# UNITED STATES PATENT AND TRADEMARK OFFICE

APPLICATION NO.	FILING DATE	FIRST NAMED INVENTOR	ATTORNEY DOCKET NO.	CONFIRMATION NO.
10/633,958	08/04/2003	Hye Suk Chi	RPS920030032US1/2805P	5183
47052 7590 01/23/2008 SAWYER LAW GROUP LLP PO BOX 51418 PALO ALTO, CA 94303			EXAMINER FERGUSON SAMRETH, MARISSA LIANA	
			ART UNIT 2854	PAPER NUMBER
			NOTIFICATION DATE 01/23/2008	DELIVERY MODE ELECTRONIC

## Office Action Summary

## **DETAILED ACTION**

**FIG. 4**

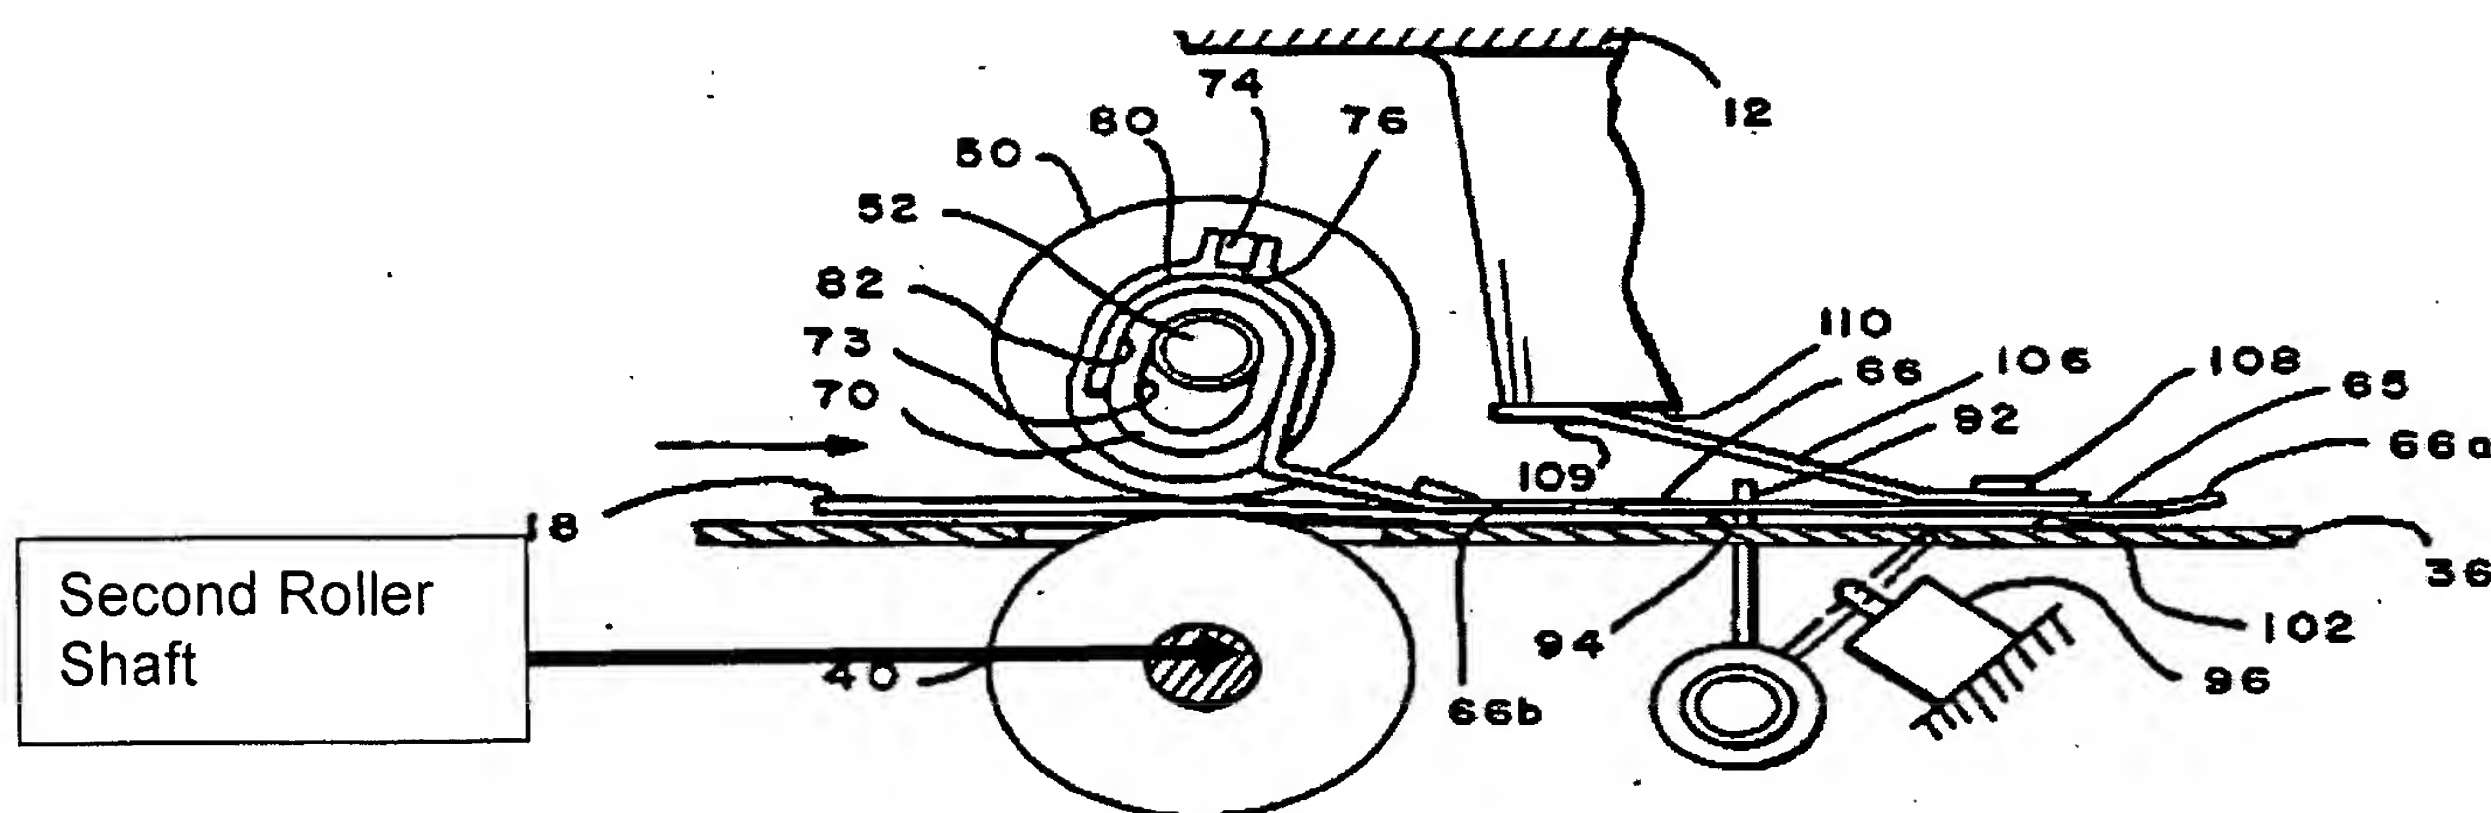
Regarding claim 15, 26, 35, 36,37 and 43, Miciukiewicz teaches a method and apparatus comprising, a second roller shaft coupled to the frame (refer to figure 4 on page 5 and figure 1 below) for advancing a document, a second roller shaft having a distal and proximal end (refer to figure 8 on page 5), wherein the distal end floats and wherein the document is removed from the path (note: this is an obvious feature).

Regarding claims 18, 29, 44 and 45, Miciukiewicz teaches a method and apparatus comprising wherein the frame further comprises a main portion (12) and front portion (10), and wherein the second roller shaft (refer to figure 1 on page 4 and figure 4 on page 5) is coupled to the main portion such that the second roller shaft does not rely on the front portion for support.

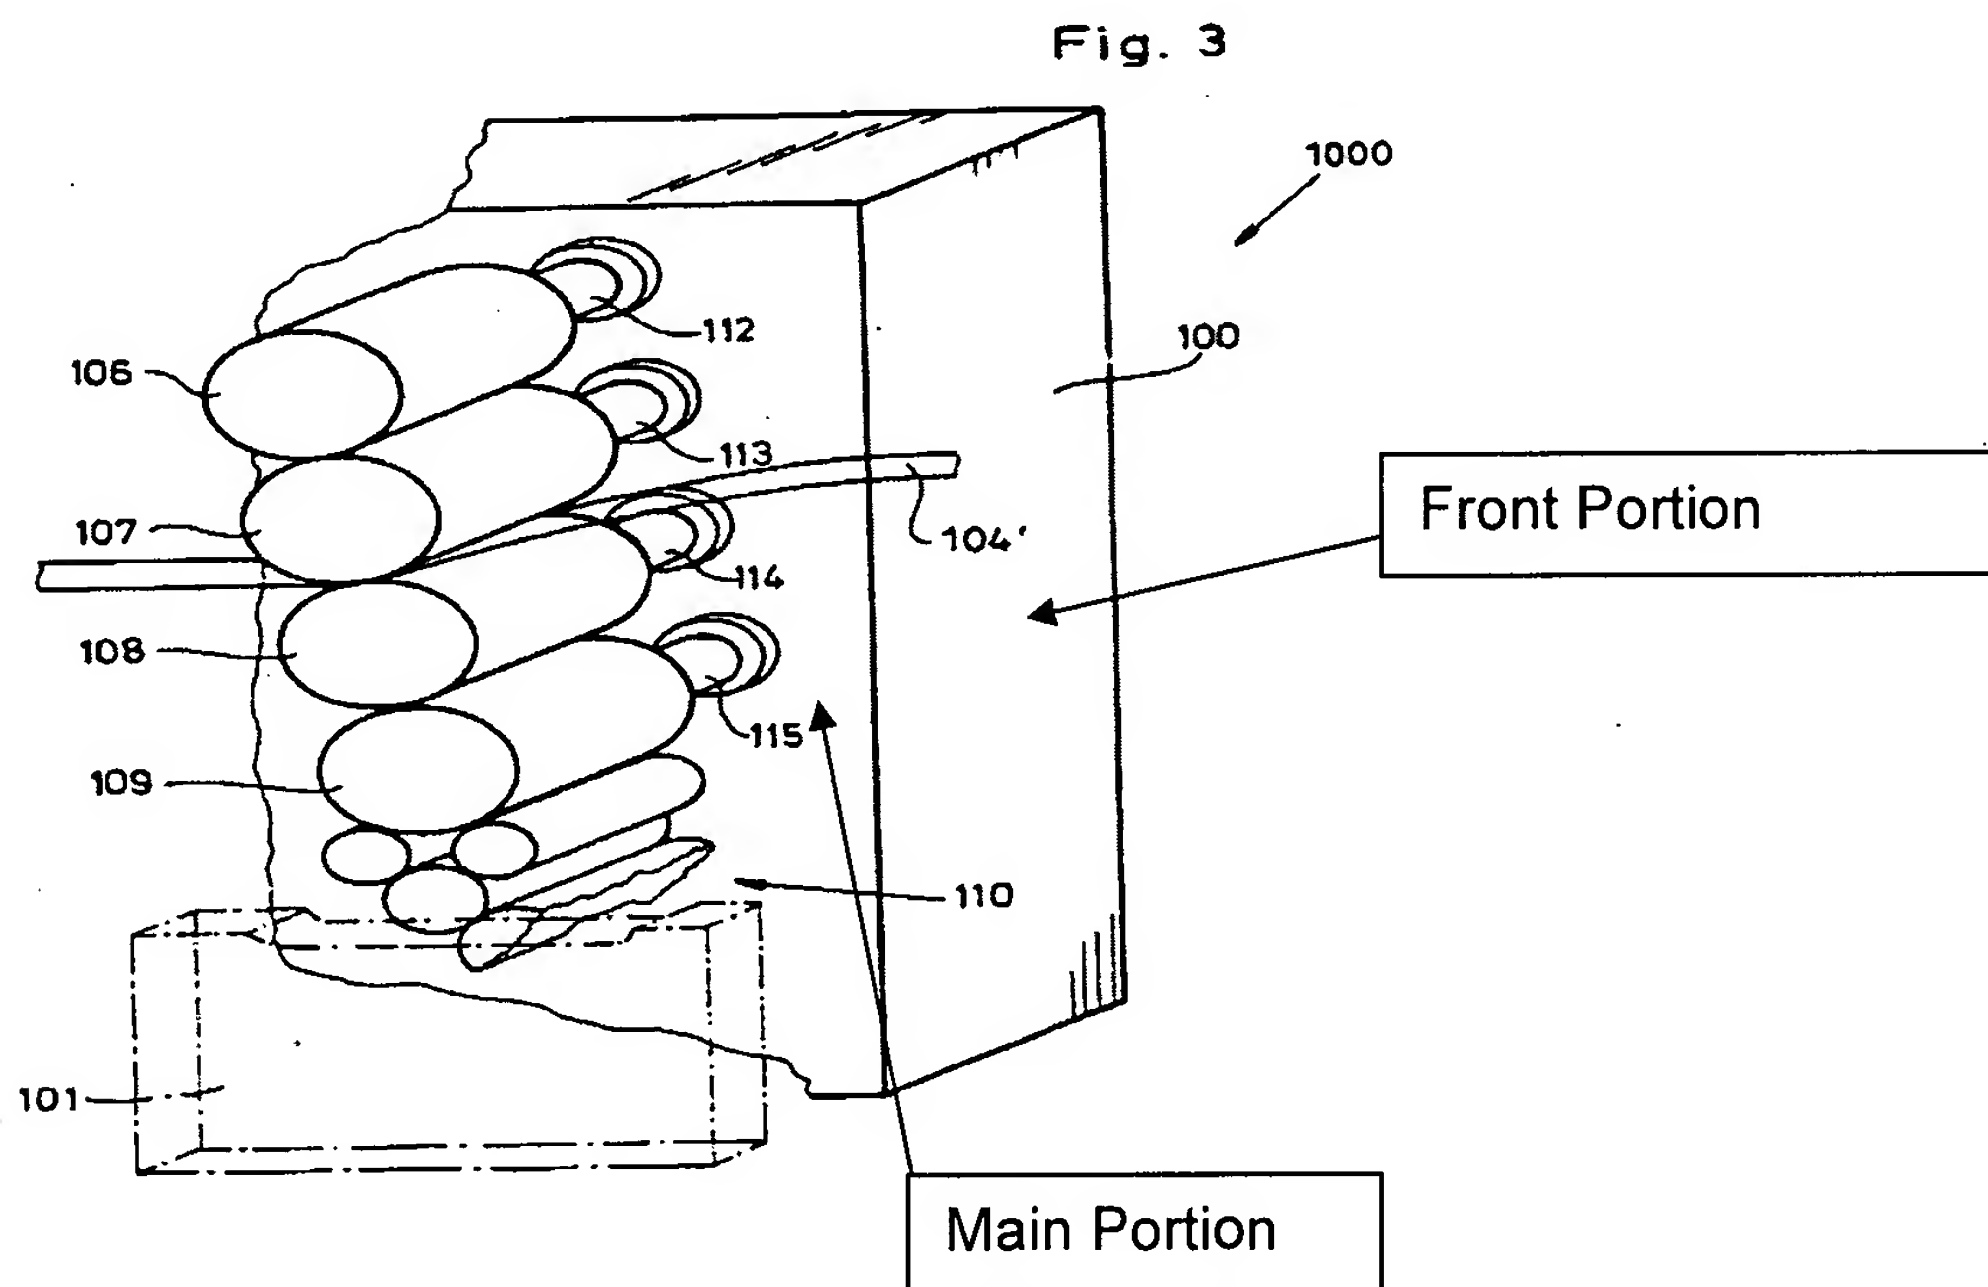
Regarding claims 1, 10, 20, 32 and 40, Guaraldi teaches an apparatus and method comprising a frame (100), at least one cantilevered roller shaft (113) comprises a distal end and a proximal end for advancing a document (104), wherein the proximal end is coupled to the frame of such that the distal end floats (As shown in Figure 3 and Column 6, Lines 14-36) and the at least one cantilevered roller shaft is supported only at one end (Figure 3) and a bearing (116). However, he does not explicitly disclose a spring coupled to the frame and the bearing such that the at least one cantilevered roller shaft is spring loaded against a drive roller shaft. Miki teaches a spring (47) coupled to the frame (10 and Figure on page 4 of the detailed action) and the bearing (1B) such that the at least one cantilevered roller shaft is spring loaded against a drive roller shaft.

Regarding claims 2, 3, 11, 12, 21, 22, Guaraldi teaches a method and apparatus wherein a supported end of the at least one cantilevered roller shaft (113) is supported at two support locations (100, 11) located outside a document path, wherein the

document can be appropriately fed (Figure 3 and Figure 6a) and wherein the need for a rigid frame directly supports the unsupported end is eliminated (Figure 3 and 6a).

Regarding claims 4, 13, 23, Guaraldi teaches a method and apparatus wherein a frame (100) further comprises a main portion and front portion (refer to figure 3 below), and wherein the at least one cantilevered roller shaft (113) is coupled to the main portion such that the at least one cantilevered roller shaft does not rely on the front portion for support (Figure 3).

Regarding claims 6-8, 15-17, 26-28, 35-37 and 43, Guaraldi teaches a method and apparatus comprising a second roller shaft (114) coupled to the frame, a second

roller shaft (114) is cantilevered wherein a second unsupported end of the second cantilevered roller shaft floats (Figures 3, 6a) and wherein a second supported end of the second roller shaft is supported two second support locations (100, 111) located outside a document path.

Regarding claims 18, 29, 44 and 45, Guaraldi teaches a method and apparatus comprising wherein a frame (100) further comprises a main portion and front portion (refer to figure 3 on page 3 of the office action), and wherein the second roller shaft (114) is coupled to the main portion such that the second roller shaft does not rely on the front portion for support (Figure 3).
